DISCUSSION

Geotechnical Engineering, Vol. 32, No. 1, pp. 45 - 46

“Downdrag Settlement a Single Floating Pile”

authored by W.H. Ting

Fig. 2. Load and Resistance Curves and Distribution of Settlement for the Mori Port Housing Case

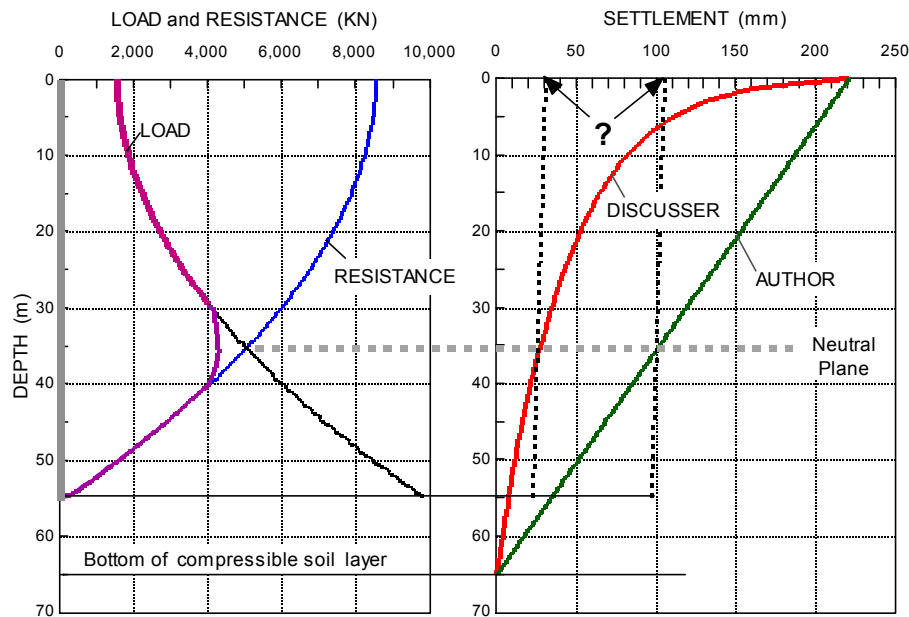
The Discusser disagrees strongly with the Author’s assumption that the settlement would reduce linearly with depth. Under the conditions presented by the Author, the settlement must reduce exponentially. Conventional backcalculation from a 224 mm ground surface settlement of a 65 m thick, normally consolidated clay layer with a density of $1,850 \text{ kg/m}^3$ (corresponds to a void ratio of 1.0) determines the C_c -value to 0.18 (the corresponding values of Compression Ratio, CR, and Janbu Modulus Number, m , are 0.90 and 25, respectively). The settlement calculated using this uniform compressibility results in a settlement at a neutral plane at about 35 m depth of only about 25 mm as opposed the Author’s value of about 100 mm.

To illustrate the comments, the Discusser performed a routine effective stress analysis of the Mori Port Housing case and the results are shown in Fig. 2. The load and resistance curves are determined by the values of the static load, 1,500 kN and toe resistance, 271 kN, combined with an assumed beta-coefficient of 0.25. The diagram indicates an assumed transition from negative skin friction to positive shaft resistance between the depths of 30 m and 40 m.

The settlement calculation has been fitted to produce a 224-mm settlement at the ground surface applying a conventional analysis using the conventional approach for clay. The settlement diagram makes it clear the large difference between the linear-proportionality method of the Author and the conventional settlement analysis method.
